**LEXINGTON-FAYETTE URBAN COUNTY
GOVERNMENT CONTRACT CHANGE ORDER**

Date:	February 6, 2020
Project:	West Hickman WWTP Scum Removal Addition and ASH Tank No. 3 Cover
Location:	West Hickman WWTP
To (Contactor): Herrick Company, Inc. 2176 Waddy Road Lawrenceburg, KY 40342	Contract No. Res # 257-2018
	Original Contract Amt. \$1,389,000.00
	Cumulative Amount of Previous Change Orders \$44,202.00
	Percent Change - Previous Change Orders 3.18%
	Total Contract Amount Prior to this Change Order \$1,433,202.00
	Change Order No. 2

CHANGE ORDER: 2

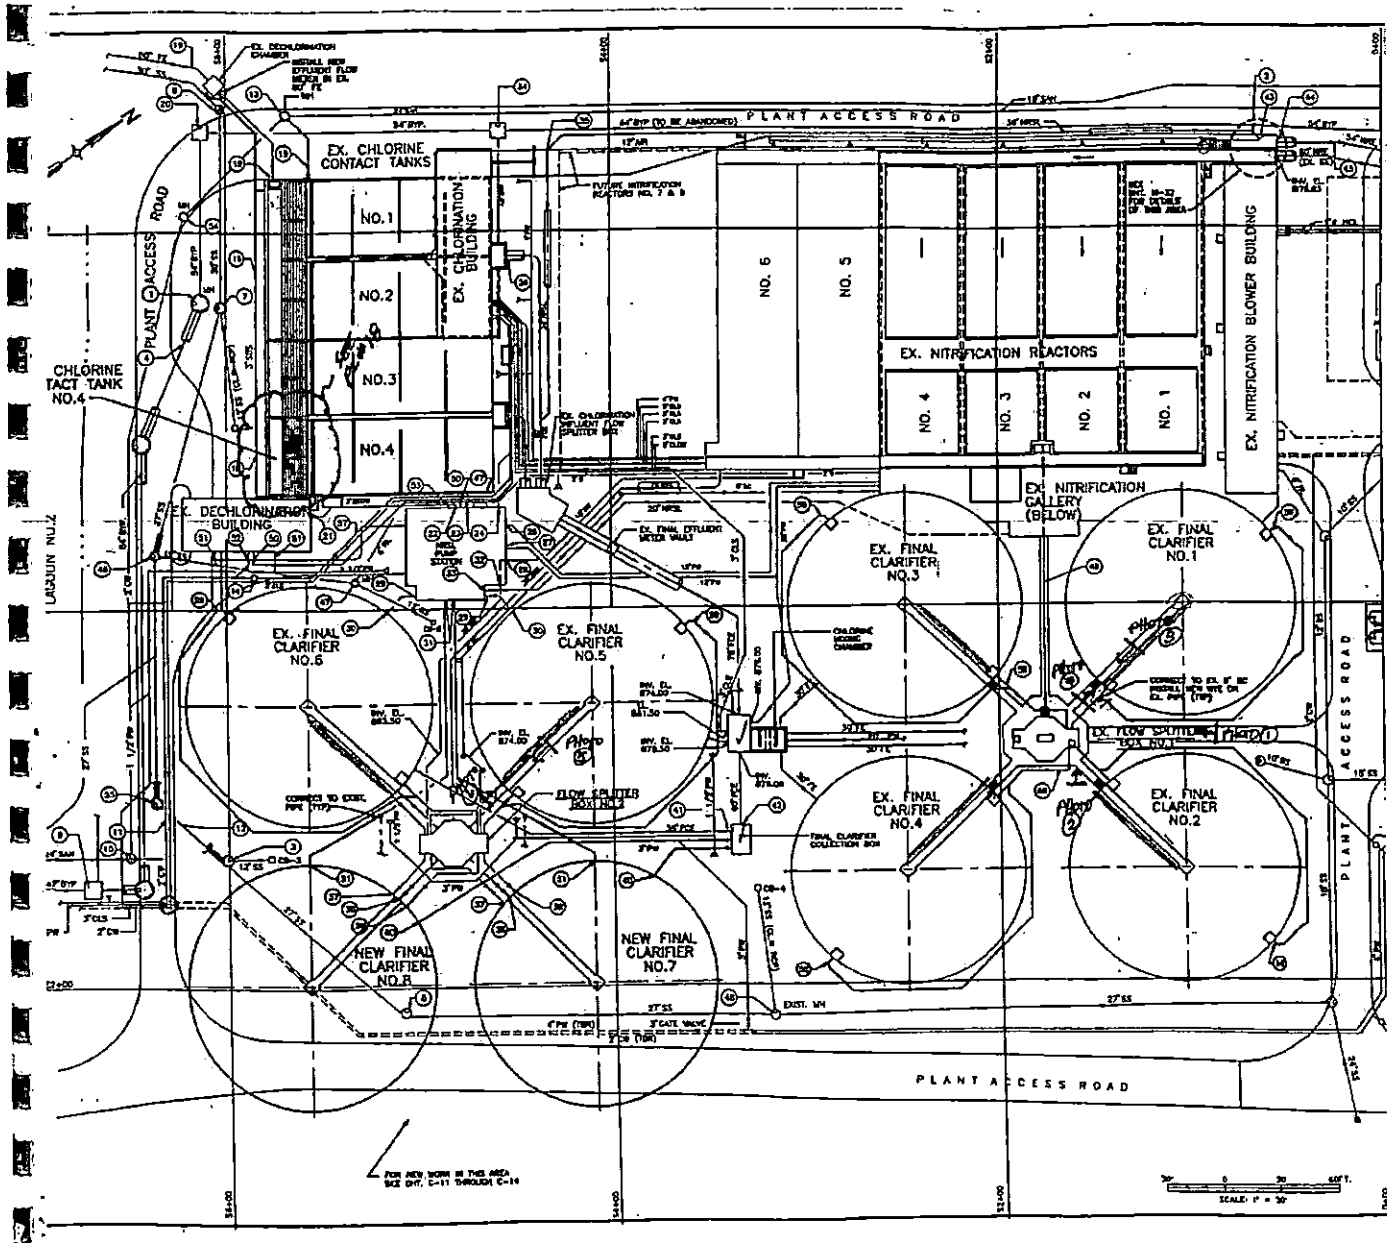
Attached are some photos and very elementary drawings but I think there is enough detail for you to give us a price. I think the only thing that needs to be confirmed are the pipe sizes and material. I think the Clarifier Scum Lines are 3" Cast Iron (Jim can you confirm?) and the Existing buried Scum Lines are 6" Cast Iron (?).

If you look at the drawing you will see that 2 of the Clarifier Scum Lines are on the same side as the existing underground scum lines but 4 are on the opposite side of the bridge. You can reroute the pipe under the bridge before turning down.

When you look at the Splitter Box Drawing you can see that the Existing Scum Line Ties in at about 6' below grade. The tie in for the Clarifier Scum Lines to the Buried lines will be between 5 and 6 foot.

We would like a price for connecting the Clarifier Scum Lines to the Existing Buried Scum Lines. There are 6 ties to be made as clarifiers #7 and #8 do not need this work completed. This junction can be done where the Scum line from the old scum box (Black on the drawings) Ys into the yellow Scum Line. Jim said that some of them have cleanouts. Hopefully they will be easy to find.

We would like cleanouts installed at the point where you make the connection and a coupling before the pipe goes underground from the clarifier. The scum pipes are not used in the winter time so we would like to be able to flush the lines once the system is out of service.

Per your request Herrick Company, Inc. offers the following for your consideration. Extend 6 clarifier scum lines from existing 3" flanges under bridges to existing 6" underground pipes. Per e mail, plans and pictures dated 10-7-19.

Existing above ground pipe is 3" galvanized steel and existing buried is assumed to be 6" DI pipe. We propose to use 3" DI flanged pipe and fittings above ground and 6" MJ pipe and fittings for buried pipe and fittings.

FINAL CLARIFIERS FLOW SPLITTER BOX NO. 1
MECHANICAL
SECTION

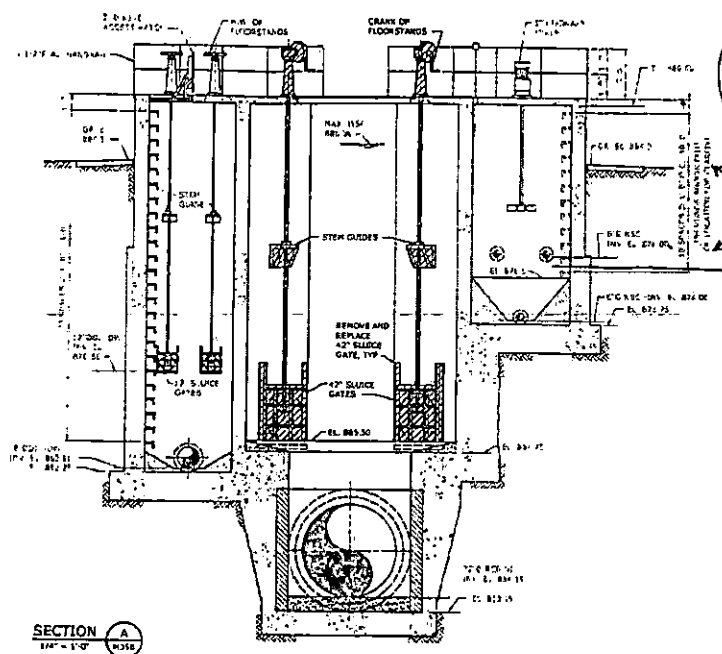
Scum lines existing that need to be tied into existing buried scum lines (yellow)

Buried scum lines, existing.

Existing scum line that will need to be capped off.

* Scum lines 2, 4, 5 and 6 will need to be re-routed under the bridge and then turned down to meet existing buried scum line.

Ground Level to pipe invert @ box is approx 6'

Existing Buried Scum Lines tied into existing Flow splitter box.
